Drinking Water Audit Report

County:	Roscommon	Date of Audit:	03/07/2014
Plant visited:	North Roscommon Regional Water Supply Scheme	Date of issue of Audit Report:	17/7/2014
		File Reference:	DW2009/320
		Auditors:	Ms Yvonne Doris
Audit Criteria:	<ul style="list-style-type: none"> • The <i>European Union (Drinking Water) Regulations 2014 (S.I. 122 of 2014)</i>. • The <i>EPA Handbook on the Implementation of the Regulations for Water Services Authorities for Public Water Supplies (ISBN: 978-1-84095-349-7)</i> • The recommendations specified in the EPA Report on <i>The Provision and Quality of Drinking Water in Ireland</i>. • The recommendations in any previous audit reports.

Photograph 1: View of Lower Lough Gara from treatment plant

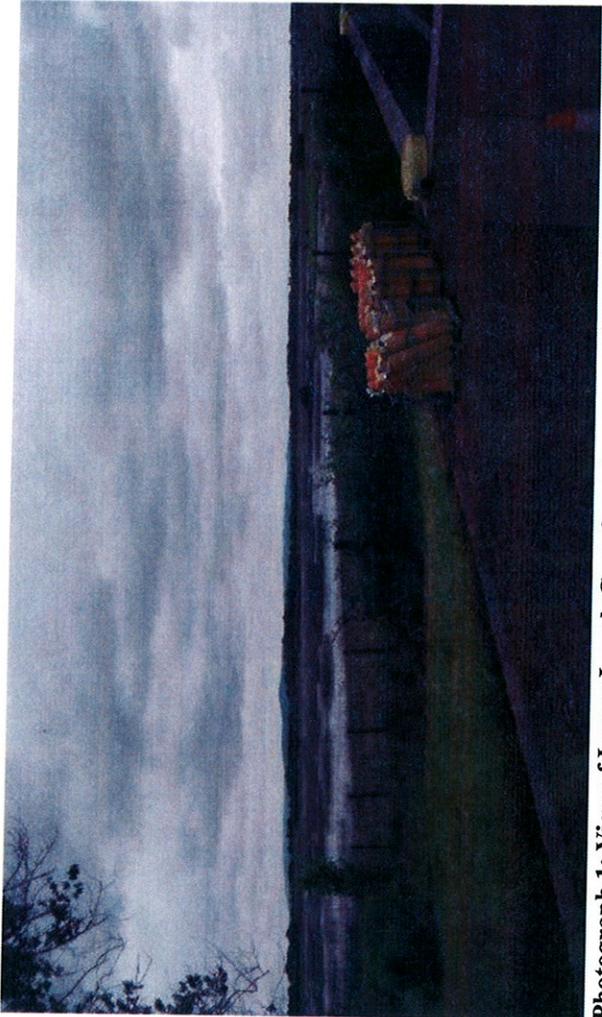
1.	<p>Source Protection</p> <ul style="list-style-type: none">a. The source is Lower Lough Gara, a shallow lake fed by the Breedoge river and possibly by a number of springs (photograph 1). The lake level varies by approximately 1.5m. The lake experiences regular algal blooms. The intake is an unknown distance from the edge of the lake. The intake has coarse screens that are not inspected or cleaned. An automatic water jet rotating screen is also in place. The intake was moved from its original location in the early 1990s following surveys. Cattle can access the lake but fencing prevents access to the area close to the intake. The abstraction is 470m³/hr for 18 hours a day.b. Raw water is monitored manually daily for colour, pH, turbidity and TOC. Raw water turbidity is usually around 3 but can be as high as 5 NTU. Raw water colour is typically 100-200 Hazen Units but can be as high as 450 Hazen Units. Raw water TOC ranges from 9 to 11mg/l. Raw water UVT ranges from 11 to 81%. At the time of the audit raw water turbidity was 3.42 NTU and colour was 100 Hazen Units.c. No farm surveys or catchment inspections have been done in the catchment. Farmers have not been written to. There are no buffer zones established. Catchment surveys will be scheduled but not in 2014. The <i>Cryptosporidium</i> Risk Assessment Score is very high risk but the score was not available at the time of the audit.

1. The Water Services Authority should ensure that the source protection and catchment risk assessment score for the *Cryptosporidium* risk assessment is reviewed and provided to the EPA.

4. The Water Services Authority should characterise the variability in raw water quality and compile a source water safety plan in order to mitigate any risks to the abstracted water (http://whqlibdoc.who.int/publications/2009/9789241562638_eng_print.pdf). Trends in raw water quality should be analysed and used to determine the optimum treatment conditions for the water at the plant. Data should be used to identify whether rapid variations in raw water quality give rise to problems with the treatment process.

Photograph 3: Overgrown reservoir on treatment plant site (built in 1991)

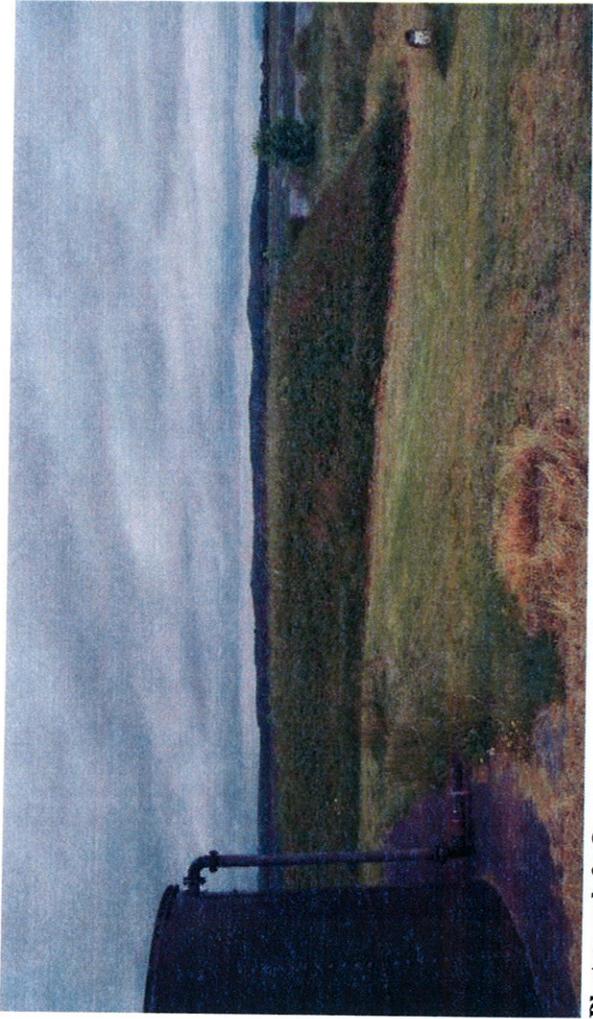
5.	<p>Treated Water Storage and Distribution Network</p> <ul style="list-style-type: none"> a. Two reservoirs are located at the treatment plant (one built in 1981 and one in 1991). There was no information available as to when they were last cleaned. Vegetation has grown over the reservoir built in 1991 (photograph 3) and access hatches were not locked (photograph 4). b. Two reservoirs are located off site. Lissacurkia reservoir and Fairymount reservoir were both built in 1989. There was no information available as to when they were last cleaned. A camera survey was conducted on the Lissacurkia reservoir in 2011. It was deemed to be structurally ok but had 4-5 inches of sediment. The Lissacurkia reservoir is overgrown and the surface could not be accessed (see photograph 5). Roscommon County Council confirmed that the access hatches were locked but that the vents were not meshed. Fairymount reservoir is a double celled round reservoir (see photograph 6). Vents were not meshed and only one of four access hatches was locked. c. Unidirectional flushing and souring is done in the network. It is done based on time every three months. Operators aim to reduce turbidity to below 1 NTU when flushing. There are parts of the network that have insufficient scour valves and therefore are not being scoured. d. Unaccounted for water is approximately 50%. Roscommon County Council has a dedicated repair crew working on leaks in the supply.

20. The Water Services Authority should remove all vegetation from the sides and cover of the reservoir built in 1991, at the treatment plant and the Lissacurkia reservoir, to ensure that the reservoirs can be visually inspected on all sides and also to prevent damage to the integrity of the reservoir.

Photograph 2: Three settlement tanks (1981)

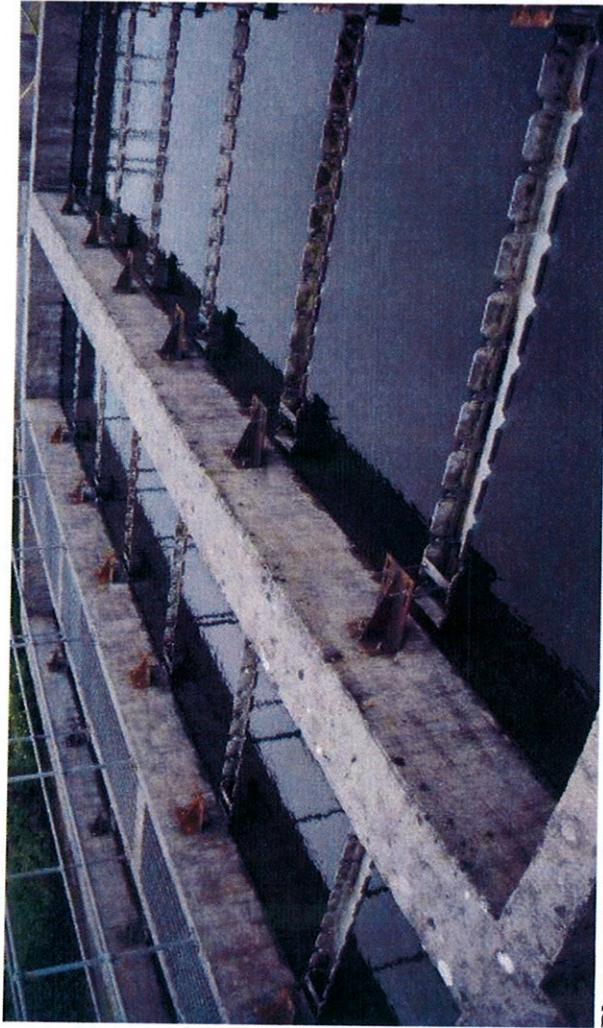
2.	<p>Coagulation, Flocculation and Clarification</p> <ul style="list-style-type: none">a. The raw water quality is highly variable. Dosing of Chemifloc 103 (aluminium sulphate/sulphuric acid mix) is flow proportional into the rising main. The dosing rate is 200-450mg/l depending on the quality of the raw water and at the time of the audit it was 260-270mg/l. Powdered carbon slurry is added at 14 ppm just prior to contact tank, to counteract a taste and odour problem but it does not solve the problem entirely and there is still an earthy, musty taste from the water. The mixing time between addition of aluminium sulphate and the poly is unknown. Poly is made up and dosed at the contact tank. The aluminium sulphate storage tank was banded since the last audit. All chemical deliveries are supervised.b. Jar tests are carried out fortnightly and the results are recorded and available for inspection.c. There are three settlement tanks with lamellae plates as part of the design (photograph 2). A number of lamellae plates were missing or broken. Once a year, each tank is cleaned out. The settlement tank was last cleaned in January 2014. The walls of the tank are cleaned out 3-4 times a year (last cleaned in early July 2014). Algae were observed on the walls of the settlement tanks. The sludge bleeds are every 20 minutes for 4 minutes (adjusted based on visual observation of bleeds). The sludge blanket in the settlement tanks appeared to be low and intact. No carryover of floc was observed. The channels were clean and level and there was a uniform upflow in the settlement tanks. The settlement tanks are exposed to cross winds.

7. The Water Services Authority should review the mixing chamber to ensure that there is adequate mixing and contact time of the coagulant/coagulant aids prior to entry into the clarifier.
8. The Water Services Authority should review the operation of the clarifier to ensure that the clarifiers are not being operated under conditions above the design capacity of the clarifier. Broken or missing lamellae plates should be replaced.
9. The Water Services Authority should ensure that the walls of the settlement tanks can be adequately cleaned on a regular basis to prevent build-up of algae and refinishing of the walls should be considered.
